THE MARYLAND-NATIONAL CAPITAL PARK AND PLANNING COMMISSION

**MEMORANDUM**

**REVIEW TYPE:** Mandatory Referral  
**PROJECT NAME:** Germantown Library

**CASE NUMBER:** 02304-F&S-1  
**REVIEW BASIS:** Article 28, Chapter 7-112 of the Regional District Act

Figure 3

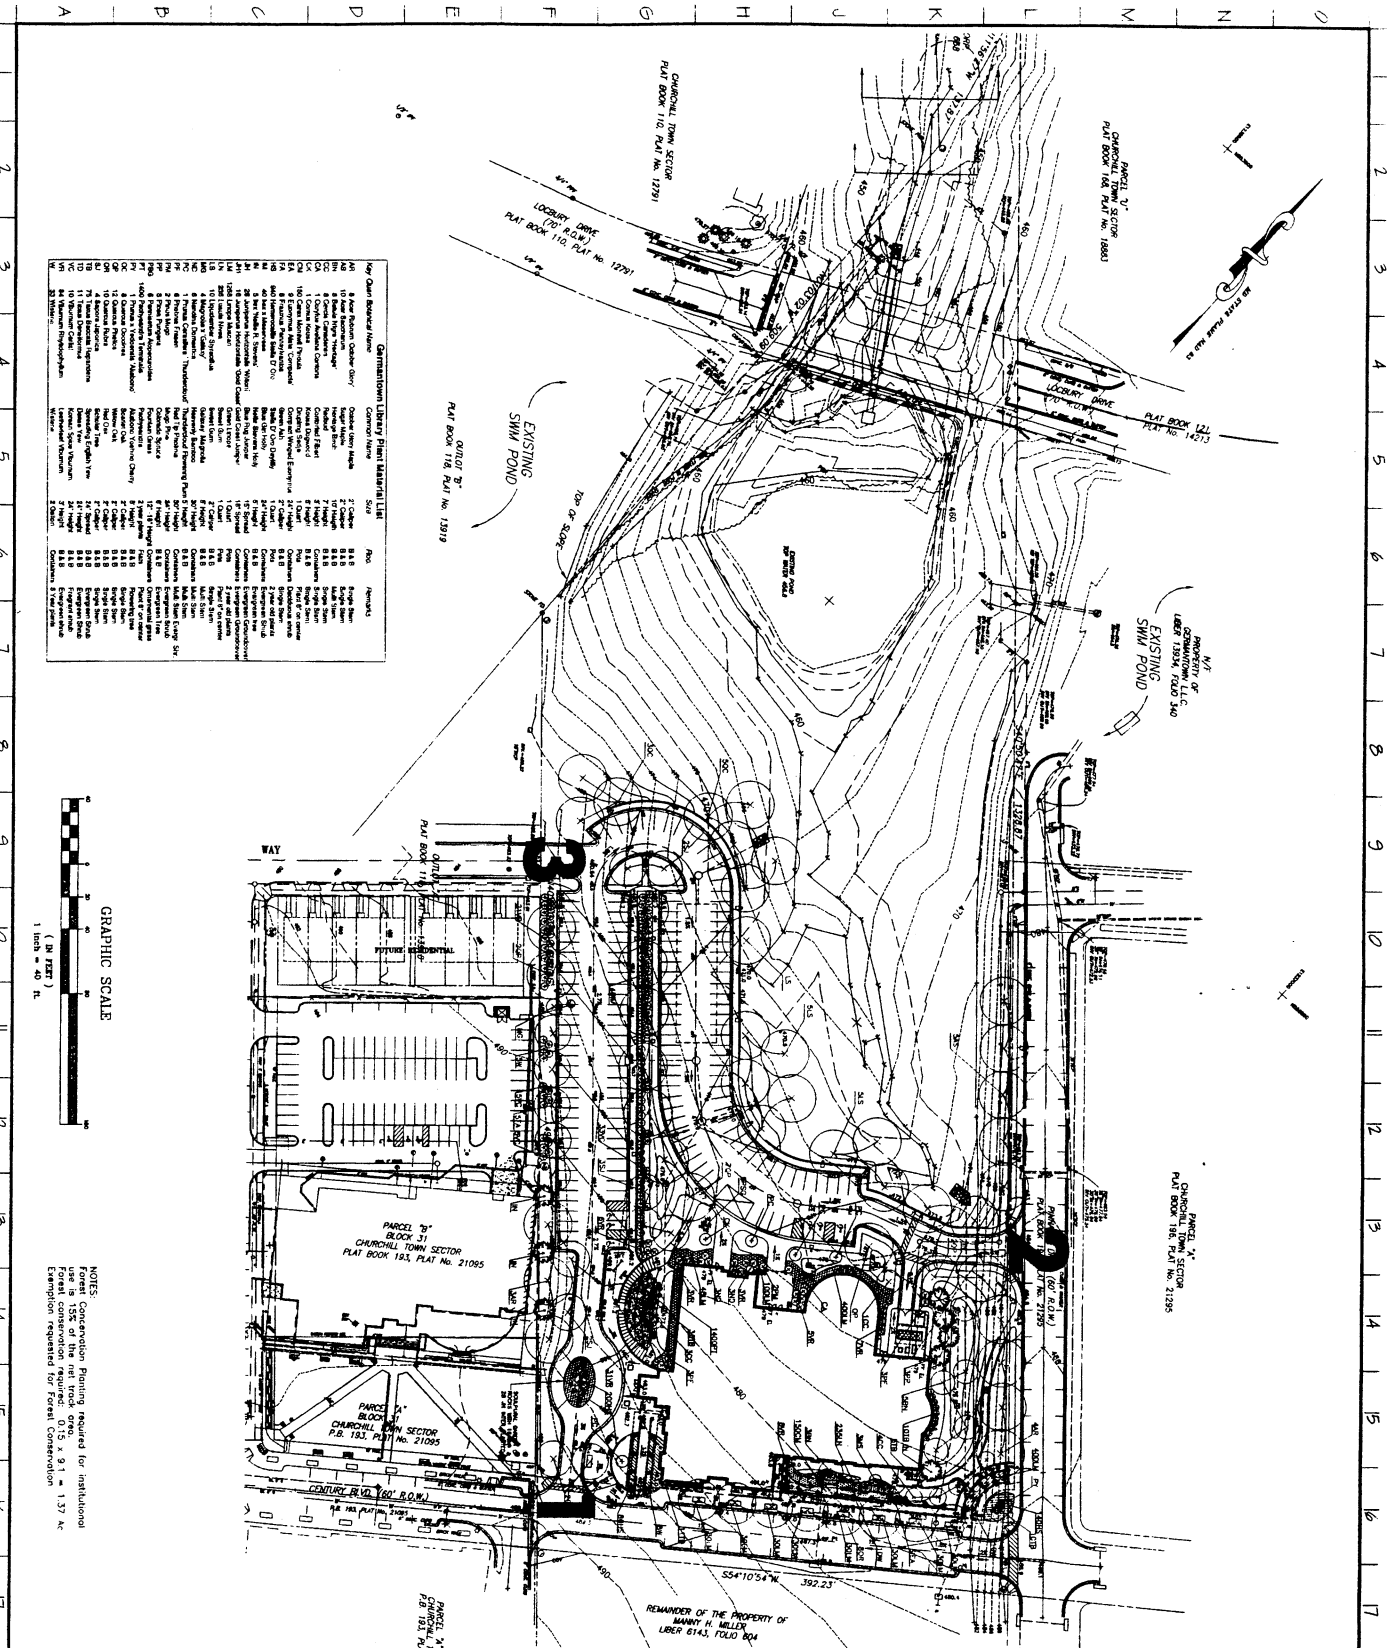
Three access points are shown on the Library Site Plan (Figure 3): (1) a one-way drive aisle from Century Boulevard; (2) from Pinnacle Drive; and (3) from Celebration Way. Entry point #1 cuts between the Town Commons and the outdoor seating area for the BlackRock Center for the Arts. This drive aisle provides direct entry into the library before gently descending to a serpentine length of double-loaded parking aisles. The library's Program of Requirements stipulates 180 parking spaces.

Entry point #2, from Pinnacle Drive, provides access to the service portions of the building as well as parking adjacent to the future park. The location of this drive avoids the wetland spring head as well as most of the wetland buffer. The finish grade of Pinnacle Drive necessitates a retaining wall over 60 feet long and varying from 5-11 feet in height which separates the library parking area from the future park.

Entry point #3, continues Celebration Way into the library/park property. The finish grade of Celebration Way and the BlackRock site requires several retaining walls totaling 240 feet in length and up to 8 feet high.

The Town Center Design Guidelines strongly support direct pedestrian connection from Century Boulevard and the Town Commons to the park. The library site plan establishes unsuitable pedestrian connections in two ways: (1) the Town Commons and Century Boulevard are separated from the library by a vehicular zone; and (2) entry into the park from any location on the library portion of the site necessitates crossing parking and circulation aisles, in addition to grade changes.

The grading proposed by the library site plan makes excessive use of retaining walls and establish an unacceptable transition to the park. These walls separate BlackRock from the library/park site and from the parking area accessed from Pinnacle Drive and the park. The site plan contains these quantities of retaining wall:

Staff finds that the proposed entrance road from Century Boulevard is not safe and efficient since it will be offset from the existing service road to the rear side of the Germantown Town Center. Staff finds that the resulting offset intersection would adversely affect vehicular and pedestrian operation and safety by creating a pedestrian crossing zone approximately 60 feet long.

1. Eliminate the access drive and drop-off between Century Boulevard and the parking lot in the rear and terminate the parking lot with a vehicular turnaround/drop-off. Align the southern edge of the turnaround with the face of the BlackRock Center for the Arts building to the west.
2. Provide additional on-street parking on the north side of Century Boulevard as a result of eliminating the access drive.

4. Reconfigure the proposed "U" turn layout of the parking lot where it accesses Celebration Way to an orthogonal layout.
5. Redesign the area created by the elimination of the access drive at Century Boulevard as an extension of the Town Center Commons.

Furthermore, staff finds that two access points (i.e. one from Pinnacle Drive and the other from Celebration Way) are adequate to provide access to the library. Staff therefore recommends the entrance road from Century Boulevard be removed so that there will be safe and efficient traffic/pedestrian circulation by having a single pedestrian crosswalk on Century Boulevard close to the existing service road intersection.

Figure 10- Staff Recommended Modifications

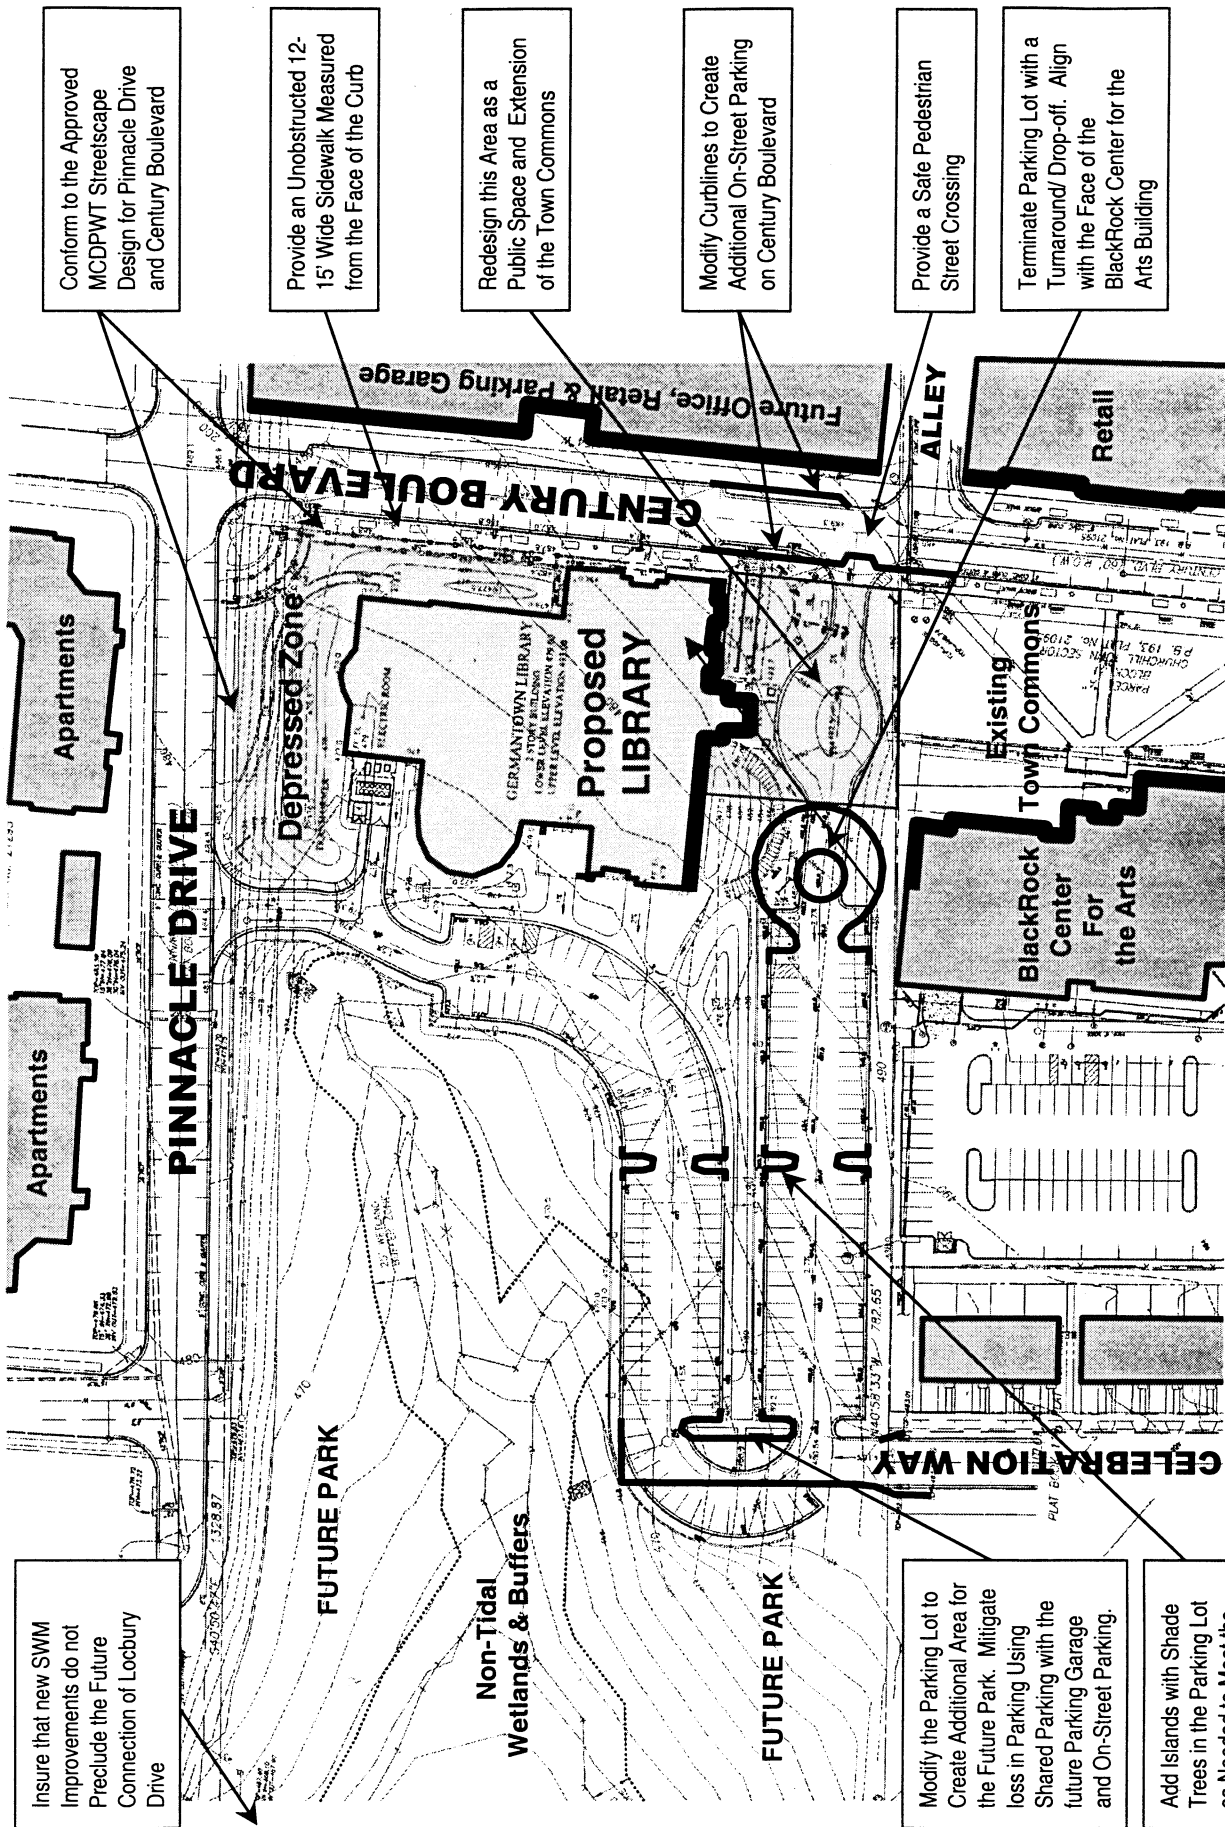
Provide an Unobstructed 12-15' Wide Sidewalk Measured from the Face of the Curb

Provide a Safe Pedestrian Street Crossing

Modify the Parking Lot to Create Additional Area for the Future Park. Mitigate loss in Parking Using Shared Parking with the future Parking Garage and On-Street Parking.

Add Islands with Shade Trees in the Parking Lot as Needed to Meet the Requirements for Internal Landscaping in the Zoning Ordinance

Figure 10- Staff Recommended Modifications

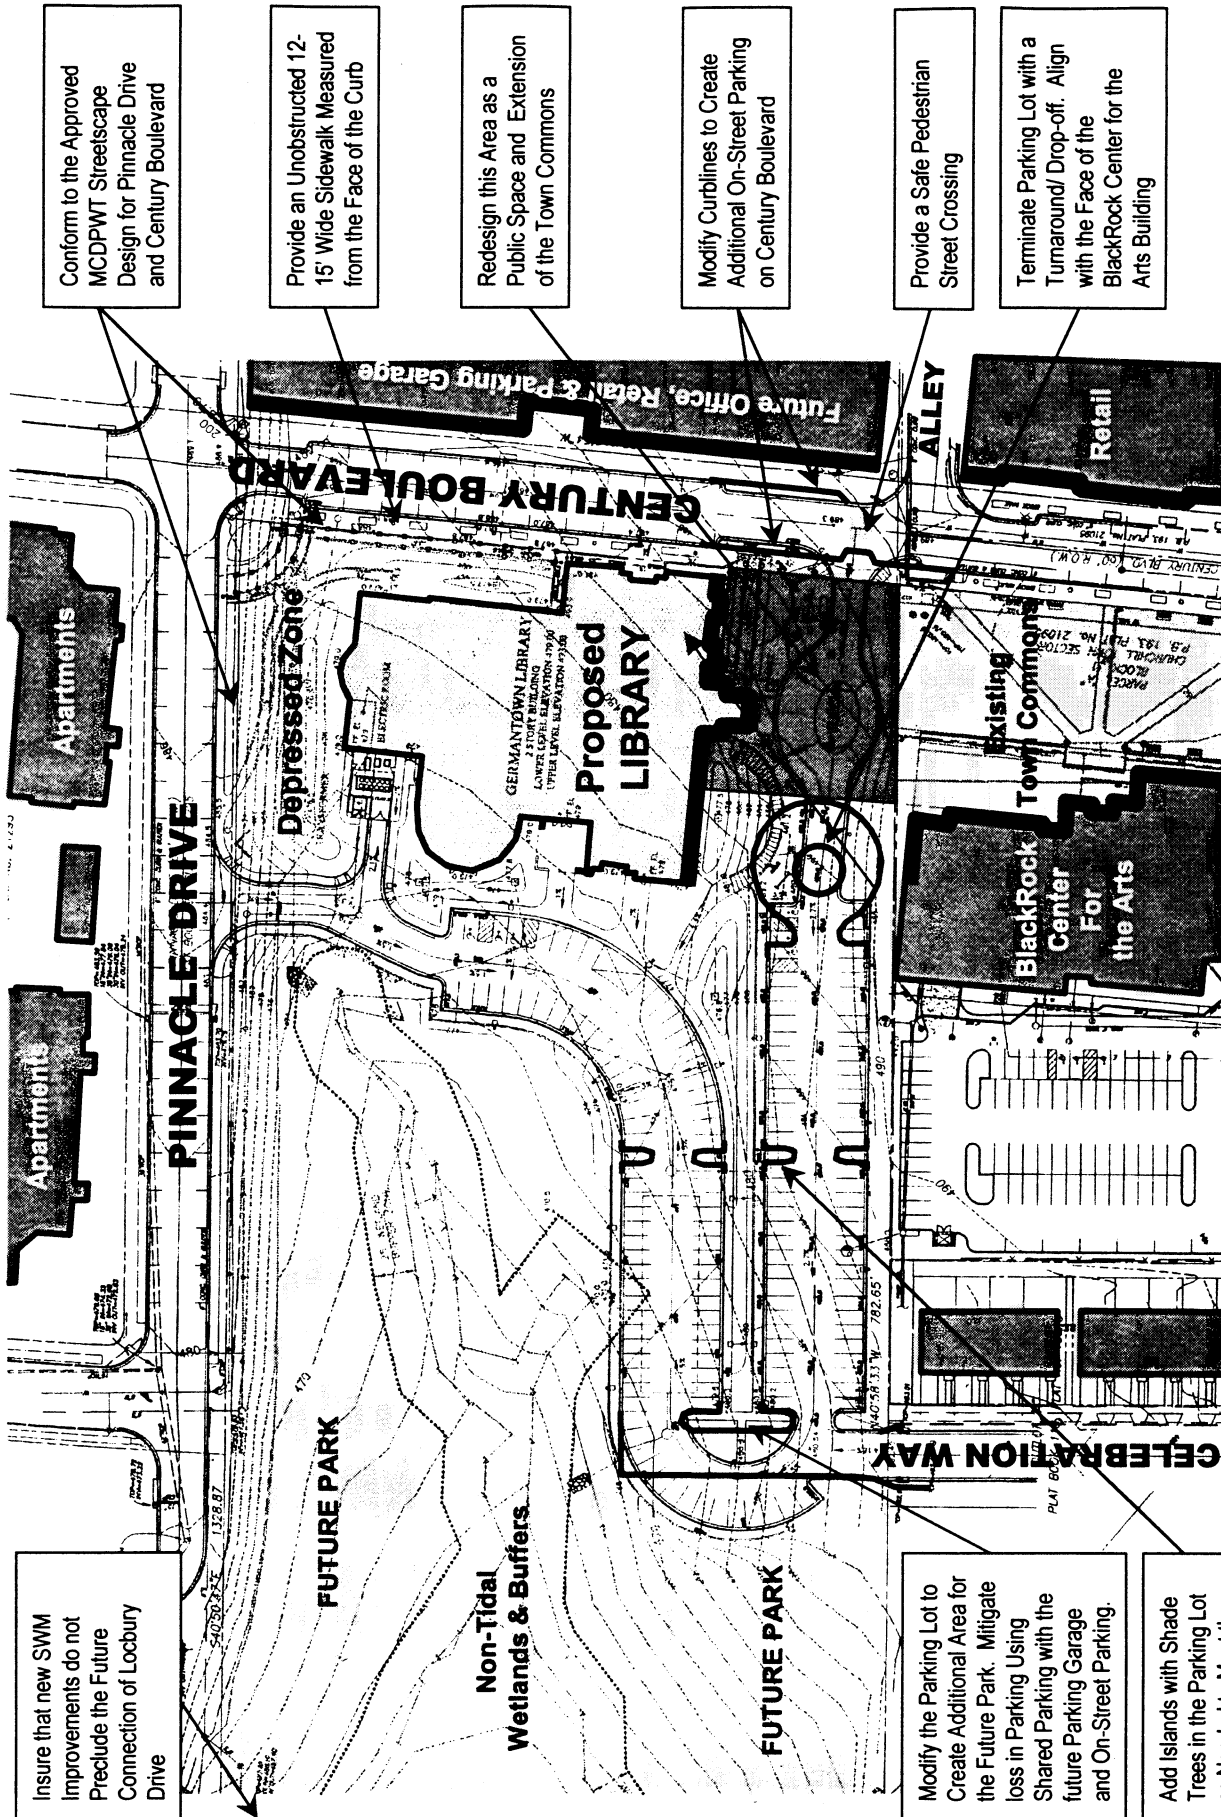
Conform to the Approved MCDPWT Streetscape Design for Pinnacle Drive and Century Boulevard

Provide an Unobstructed 12-15' Wide Sidewalk Measured from the Face of the Curb

Provide a Safe Pedestrian Street Crossing

Add Islands with Shade Trees in the Parking Lot as Needed to Meet the Requirements for Internal Landscaping in the Zoning Ordinance
